COMMUNITY DEVELOPMENT DEPARTMENT REPORT

SUBJECT: Thruston Choi Farms Subdivision
H-2026-0053

Preliminary plat to subdivide two (2) existing parcels into six (6) building lots in the I-L zoning district on 22.26 acres of land.

B. Landscape Plan (date: 8/17/2026)

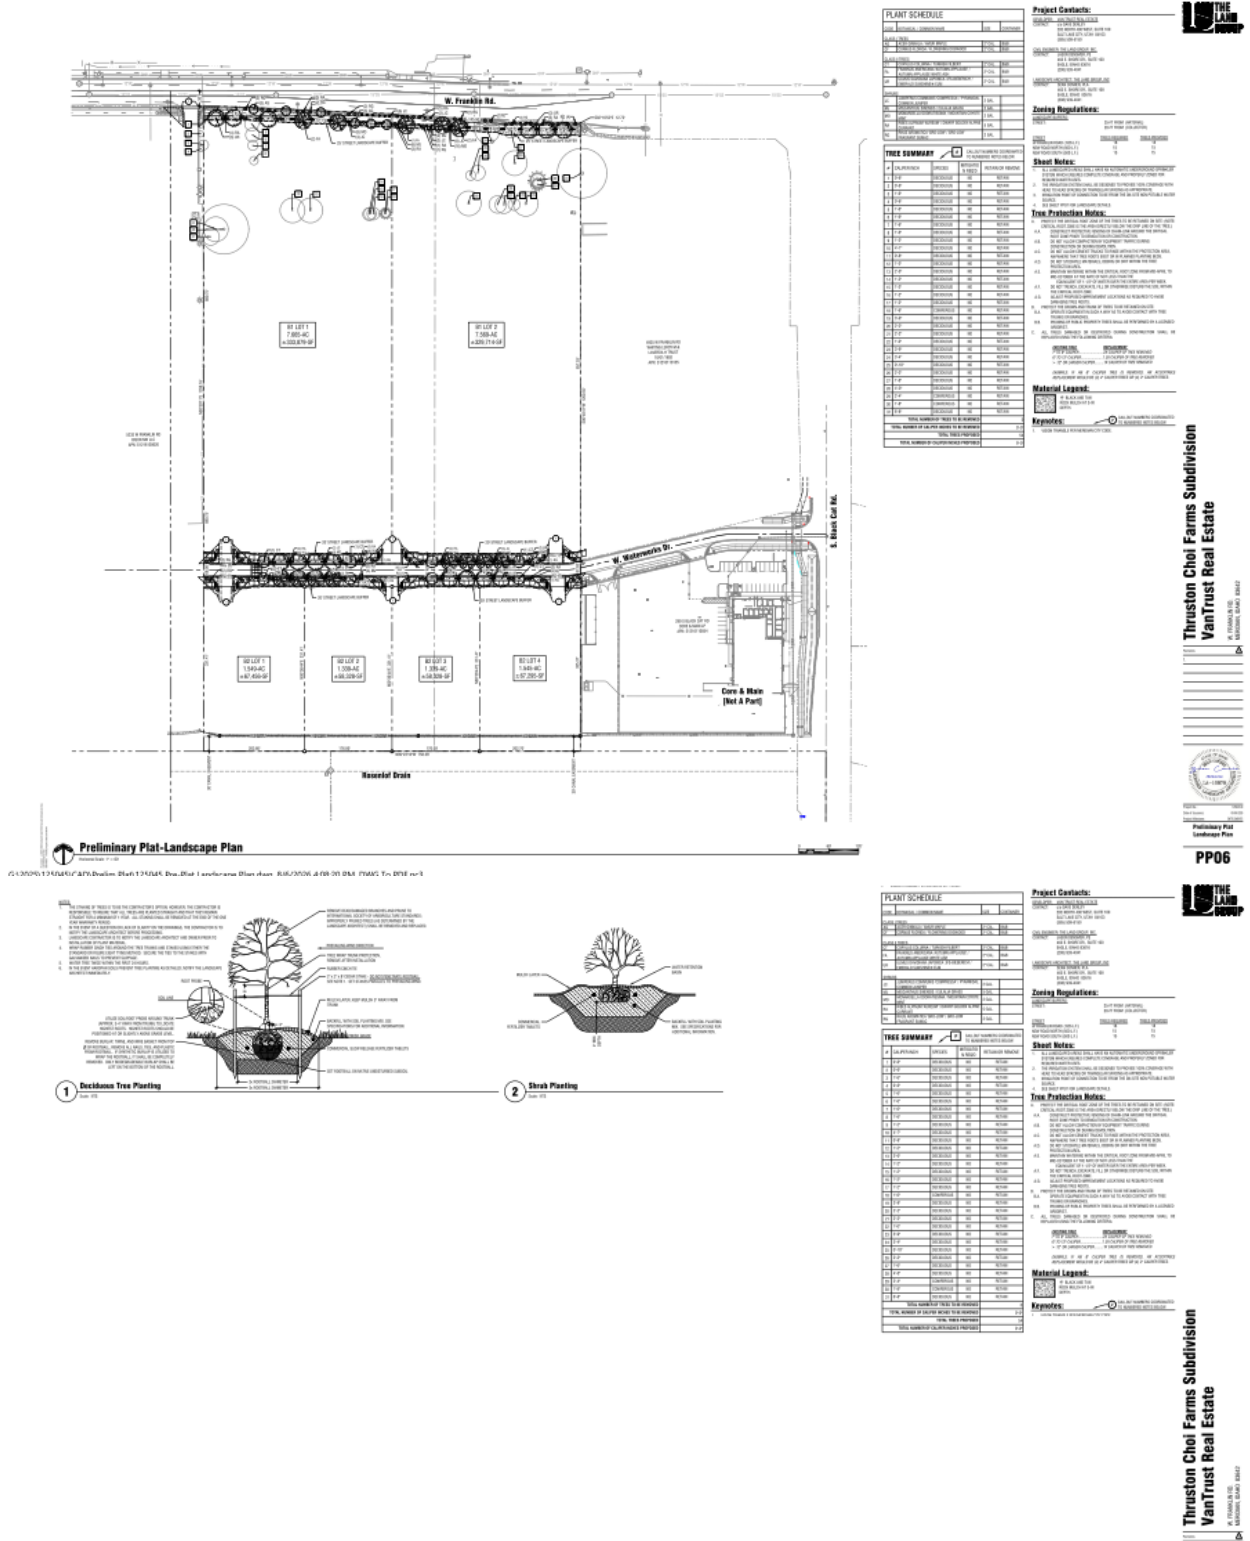
UDC Requirement	Proposed/Analysis
Arterial Road: 25 Feet	The applicant is proposing a 25-foot landscape buffer along Franklin Road. However, it appears a portion of the landscaping will be in ACHD’s right of way. Prior to recording the plat, the applicant shall provide a license agreement for landscaping in the right of way. In addition, the applicant shall revise their landscape plan to meet the

UDC Requirement	Proposed/Analysis
Collector Road: 20 Feet	vegetation coverage requirements of 70%, and provide a mix of plantings as outlined in UDC 11-3B-7. The applicant is proposing a 20-foot landscape buffer along W. Waterworks Drive. However, it appears most of the landscaping will be in ACHD's right of way. Prior to recording the plat, the applicant shall provide a license agreement for landscaping in the right of way. In addition, the applicant shall revise their landscape plan to meet the vegetation coverage requirements of 70%, and provide a mix of plantings as outlined In UDC 11-3B-7.

UDC 11-3A-17 requires parkways of a minimum width of 8 feet. The applicant has indicated in their narrative that the parkways are 8 feet in width, however it is not dimensioned on the landscape plan. The parkways shall be dimensioned and a minimum of 8 feet in width in the final plat application.

4. The landscape plan submitted with the final plat shall be revised as follows:
 - a. Depict landscaping within required street buffers in accord with standards listed in UDC 11-3B-7C; all required landscape buffers along streets shall be designed and planted with a variety of trees, shrubs, lawn, or other vegetative ground cover. Plant materials in conjunction with site design shall elicit design principles including rhythm, repetition, balance, and focal elements.

- b. Prior to recording the plat, the applicant shall provide a license agreement for landscaping in ACHD right-of-way.
 - c. Revise the landscape plan to meet the vegetation coverage requirements of 70%, and provide a mix of plantings as outlined in UDC 11-3B-7.

- d. Revise the plat and landscape plans to include the dimension of the 10-foot wide sidewalk along W. Franklin Road.
 - e. Sidewalks, walkways and pathways shall include dedicated crosswalks at the intersection with all streets of W. Waterworks Drive with changes in color, markings, materials, texture and/or surface to distinguish them from the surrounding pavement as set forth in the TMISAP (see pg. 3-28, Crosswalks).

C. Preliminary Plat (date: 8/17/2026)

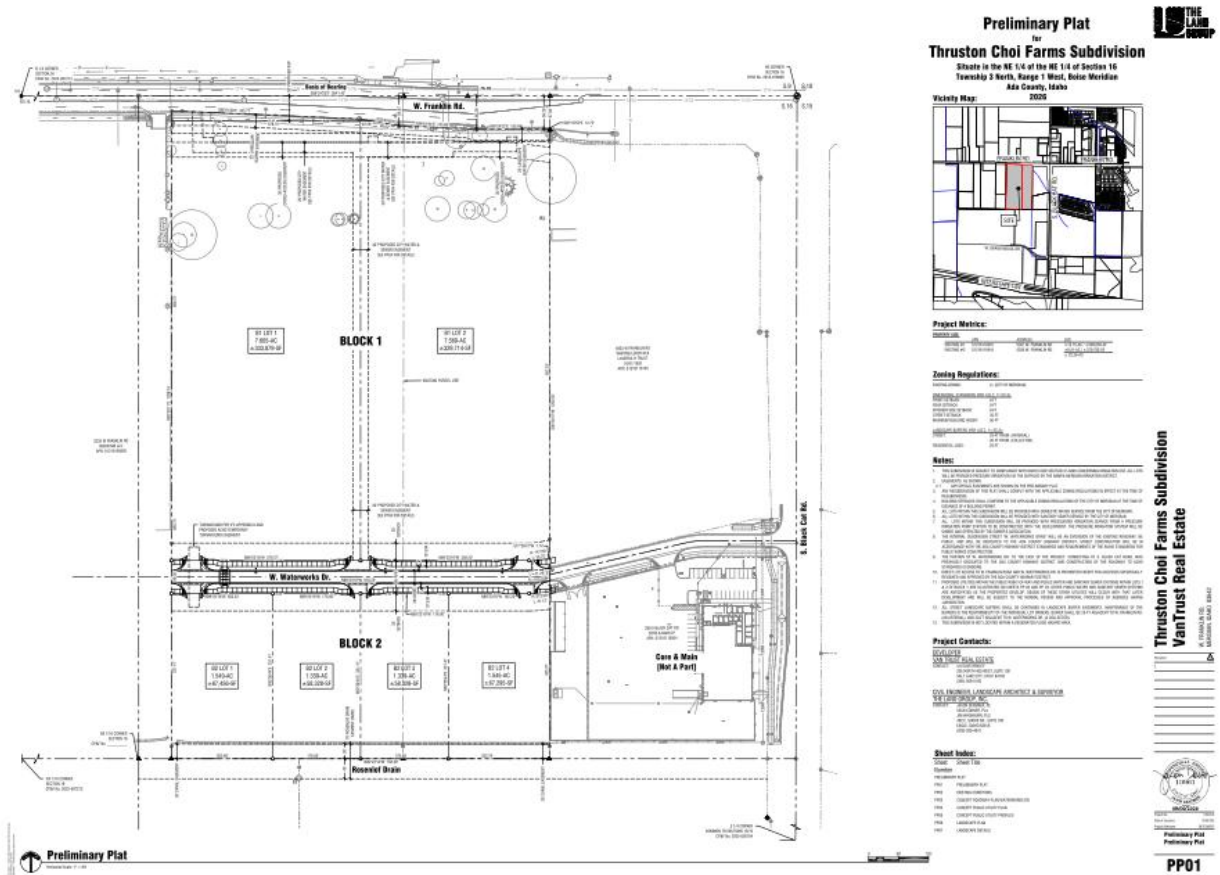
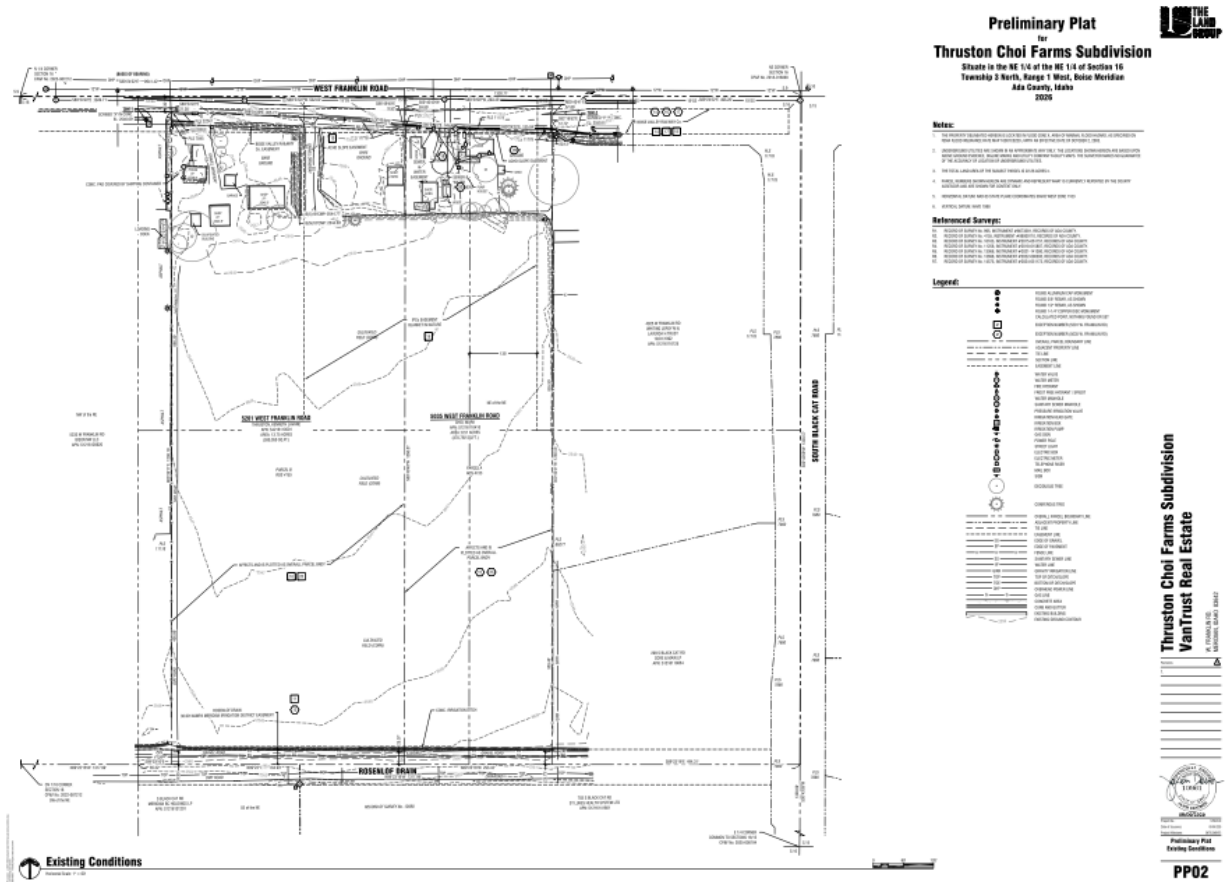
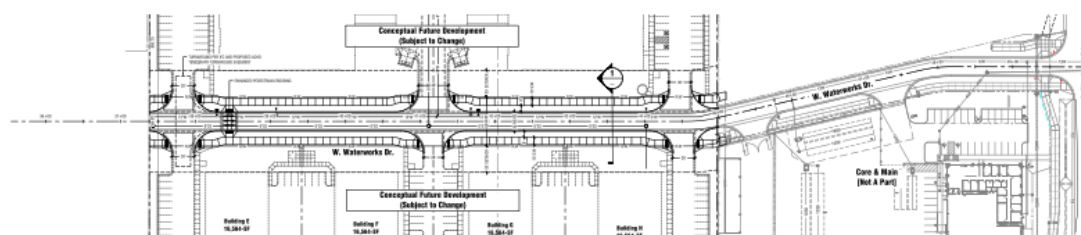
- The two (2) eastern access points on the collector roadway are not approved as shown. These access points do not meet the offset requirements from access directly to the east.

ACHD's staff report identifies 6 access points to Waterworks Drive, 2 of which do not meet district policy. The two eastern access points do not meet the required offset standards and are recommended for closure. City staff supports ACHD's findings and has included conditions requiring the closure of these two access points.

- b. Add a plat note stating a blanket cross-access easement encumbers all lots within the subdivision and record a cross access agreement with the property to the east. In addition, add a note that references the recorded CCR's in effect for the development.

- c. Provide details on the plazas throughout the development.
 - d. Close the two eastern access points off of Waterworks Drive in accordance with UDC 11-3A-3 and ACHD's conditions.
